TECHNICAL SERVICE BULLETIN

Bulletin Number: L-16-01

VERSION: R01 (December 19, 2016)

2016-2017 GEM Drive-Mode Switch Replacement

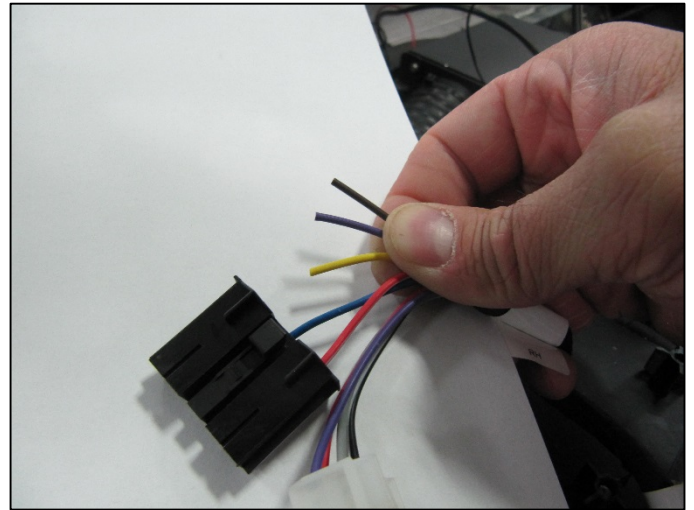
7. Locate the new drive-mode switch (A).
8. Install rubber gasket to back-side of switch (B).
9. Orient the new drive-mode switch so that the drive-mode indicator letters can be read, and firmly press switch into the cut-out to engage the retaining tabs.
10. Install bracket mount (C) onto the back of the switch behind the dash, engaging retaining tabs.

11. Attach wire harness to switch.

A secondary dealer representative must confirm that the new drive-mode switch is mounted correctly, fits properly, and is well retained.

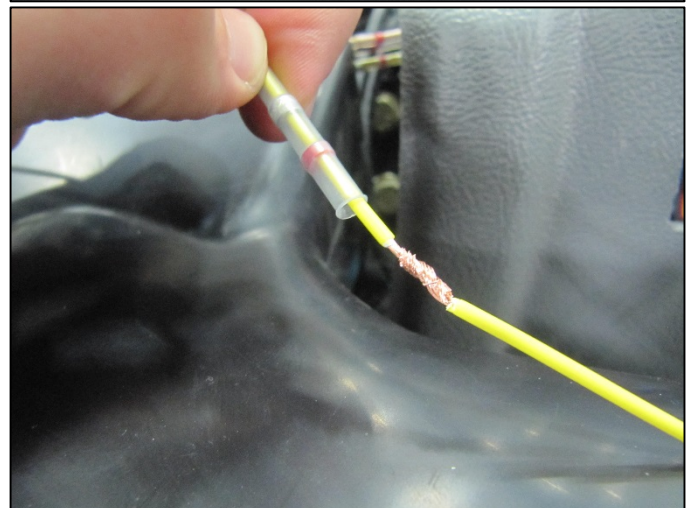
12. Locate the black connector for the right-hand stalk switch that was disconnected earlier.
13. Remove approximately two inches of the tape back from the wires to the Y-junction. Cut the cable tie if applicable.
14. Locate the brown, violet, and yellow-white wires on the black connector.

15. Cut the brown, violet, and yellow-white wires flush with back side of the black connector as shown.

16. Strip the brown, violet, and yellow-white wires. The strip length must be approximately 1/4".

MEASUREMENT
Wire Strip Length: 1/4" (6 mm)

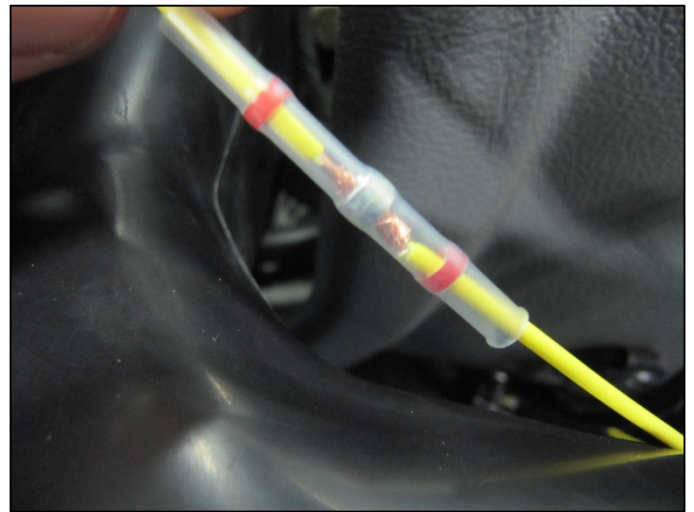
17. Slide the solder sleeve over a wire from the vehicle harness wires as shown.

18. Locate the corresponding wire from the right-hand stock harness.

- a. Violet to Violet
- b. Brown to Brown
- c. Yellow-White to Yellow-Brown

19. Tightly twist the wires together as shown.

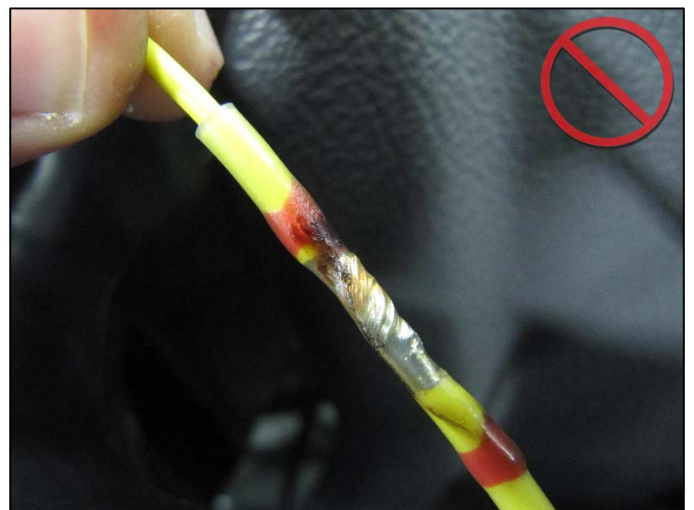
20. Center the solder sleeve over the twisted wires

21. Evenly apply heat to the solder sleeve until the sleeve has contracted and the solder ring has evenly melted into the wires.

Acceptable – Solder is fully melted and sleeve has contracted.

Unacceptable – Inadequate heat. Contour of the solder ring is clearly visible.

Unacceptable – Excessive heat. Sleeve is burnt and has left the wires exposed.

A secondary dealer representative must confirm the correct wires were paired, and the solder splices were properly installed and heated.

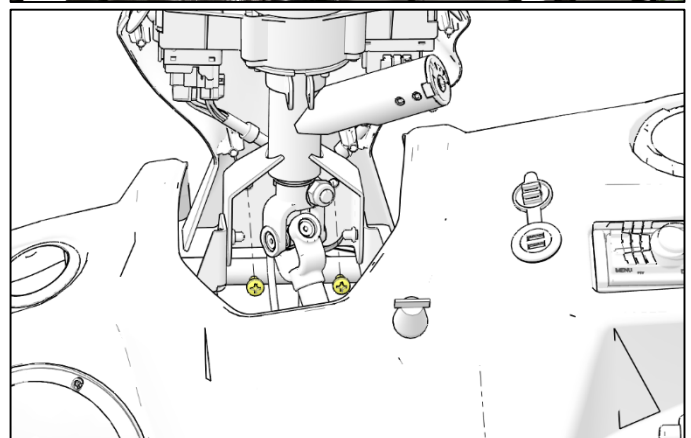
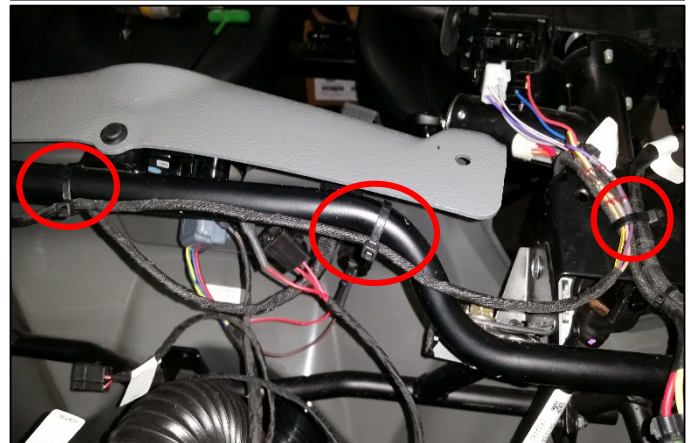
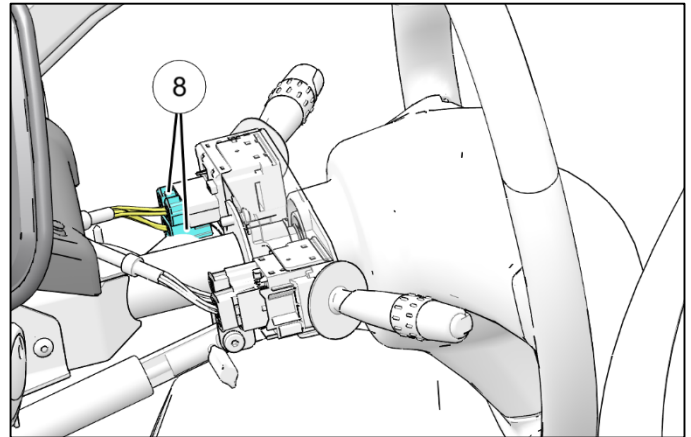
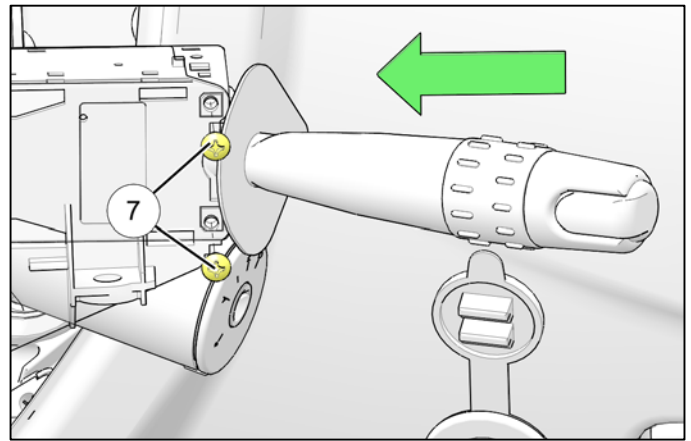
23. Install the new right-hand stalk switch onto the vehicle.
Torque screws ⑦ to specification.

Right-hand Stalk Screw:
24 in-lbs (3 Nm)

A secondary dealer representative must verify that the new right-hand stalk switch has been installed and confirm the stalk arm cannot be actuated up and down.
